<b>CASE</b>	UDP-S24072
<b>PROJECT NAME</b>	Broward Health Medical Center (BHMC) Medical Office Building and Parking Garage
<b>APPLICATION TYPE</b>	Site Plan Level II
<b>APPROVAL LEVEL</b>	City Commission Approval
<b>REQUEST</b>	Design Deviations for Additional Building Height Greater than 110 Feet in Height for 204,589 Square Feet of Medical Office Use
<b>APPLICANT</b>	North Broward Hospital District
<b>AGENT</b>	Stephanie Toothaker, Esq.
<b>PROPERTY ADDRESS</b>	1601, 1603, 1611, 1627, and 1632 S. Andrews Avenue
<b>ABBREVIATED LEGAL DESCRIPTION</b>	Croissant Park Resub Blk 38 52-8 B Lots 1 To 12, 17 and 18, 21 To 24
<b>ZONING DISTRICT</b>	South Regional Activity Center-South Andrews east (RAC-S Ae)
<b>LAND USE</b>	South Regional Activity Center
<b>COMMISSION DISTRICT</b>	4 - Ben Sorensen
<b>NEIGHBORHOOD ASSOCIATION</b>	Poinciana Park Civic Association
<b>SUBMITTAL</b>	December 13, 2024
<b>COMPLETENESS ISSUED</b>	December 19, 2024

Case Number: UDP-S24072

**SECTION 1027  
EXTERIOR EXIT STAIRWAYS AND RAMPS**

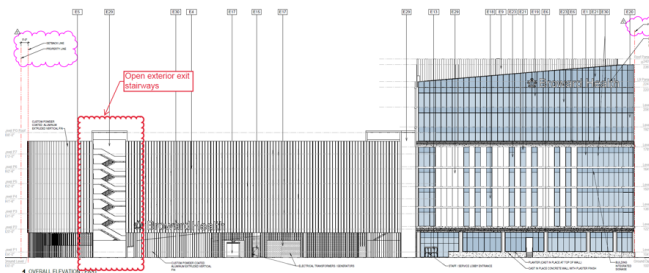
**REV 1 Response:** Added clarifying annotations to Accessible Passenger Loading and Drop Off Area. Refer to sheet:  
A1.01.1 - OVERALL SITE PLAN
7. **New Comment:** I noticed the open exterior exit stairways show below, which are not allowed per Section 1027.2 of the FBC for high-rise buildings. If the parking garage and medical building are separate buildings with the required fire wall rated assemblies from the foundation to the roof deck, then this is not an issue. Please consult with the design team and let me know.

I noticed the open exterior exit stairways show below, which are not allowed per Section 1027.2 of the FBC for high-rise buildings. If the parking garage and medical building are separate buildings with the required fire wall rated assemblies from the foundation to the roof deck, then this is not an issue. Please consult with the design team and let me know. Note that the parking garage would not be considered a high-rise since is less than 75 ft to the occupiable floors.

Can you add a note on the drawings addressing this issue.

**REV 2 Response:** The garage is not a high-rise, the garage height to highest occupied floor P-7 is at 73' which is less than 75'. 3-hour rated fire wall separates the garage from MOB tower. Please see architectural General and code information sheet G1.01.1, G2 Code compliance series, and Exterior elevations on A7 series

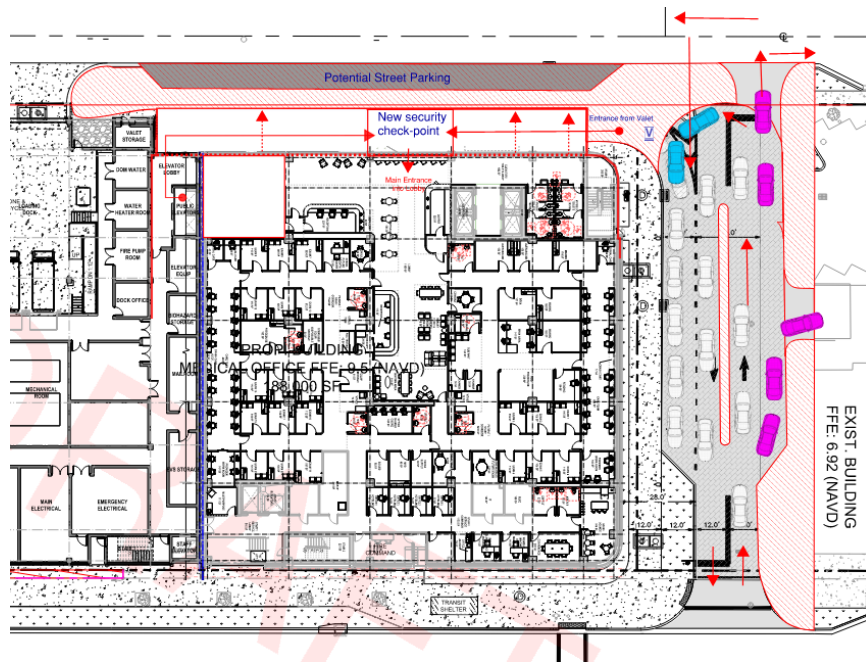
**Comment 4/11/2025:** Construction fence still encroaching onto 25 x 25 visibility triangles. To be addressed at time of permitting.

**REV 2 Response:** Noted, construction fence has been adjusted away from visibility triangles. Refer to revised plans.

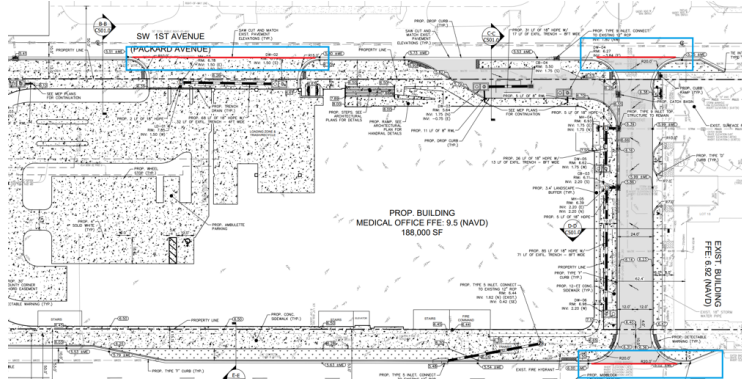
**REV 2 Response:** Acknowledged, site plan will be updated per ongoing coordination with City staff. Drop off will not be within the right-of-way. See snip it below.

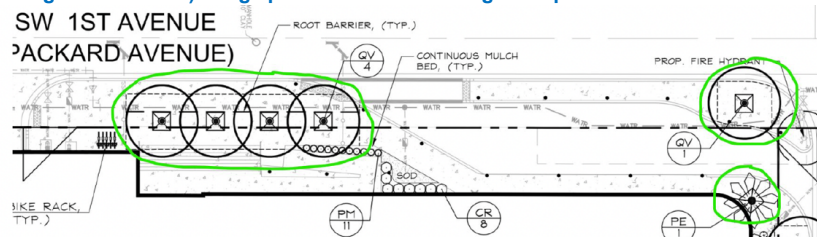
a. See below for example of conflict between civil and landscape plans along SW 1st AVE. Civil plans propose existing water main to be cut, plugged and abandoned. New main to be installed within ROW, south of the proposed garage entrance curb cut. Please coordinate landscape plans to match. Street trees in this area won't require root barrier for abandoned main and can be specified at full size with structural soil.

**REV 2 Response:** Plans have been updated per request, refer to revised plans.

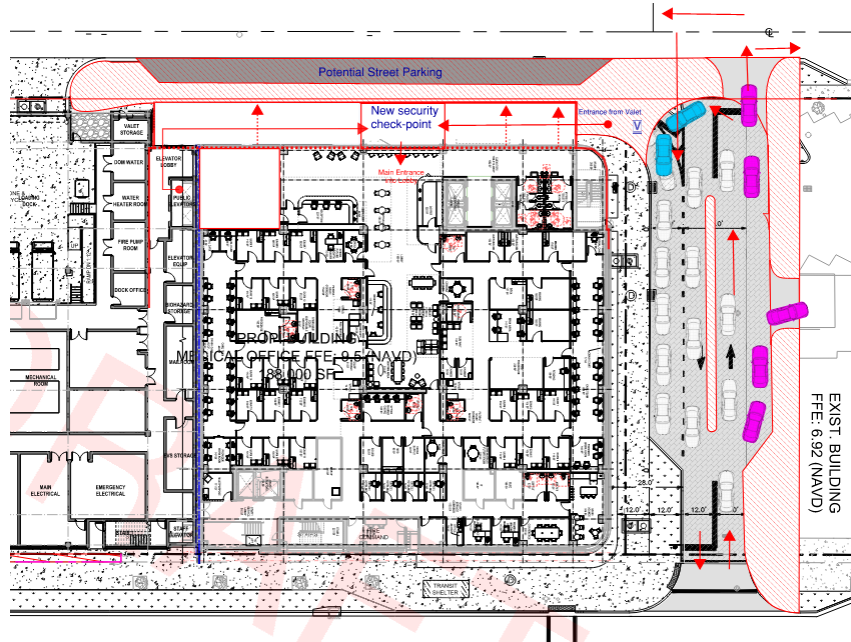
- o. Per the SRAC Master Plan the maximum travel lane width shall be ten feet. Increase the sidewalk and swale width of SW 1st avenue and remove the drop-off lane that encroaches into the public right-of-way, as well as any sidewalk pinch points. With the removal of the drop-off lane additional trees can be provided. Because no on-street parking is being provided, an approximate 12-foot-wide unobstructed sidewalk can be provided, with a 10-foot-wide landscape swale, and two-foot curb and gutter. Reference image below for additional context. Note: Consider internalizing the drop-off between the existing and proposed building on the vacated portion of SW 16th Street. Reference the image below for additional context.

**REV 1 Response:** Lane width along SW 1st Avenue has been decreased to 10 feet in accordance with the SRAC Master Plan. Drop-off lane has been reconfigured to provide continuous sidewalk transit. Refer to sheet C200.0 and C500.0.
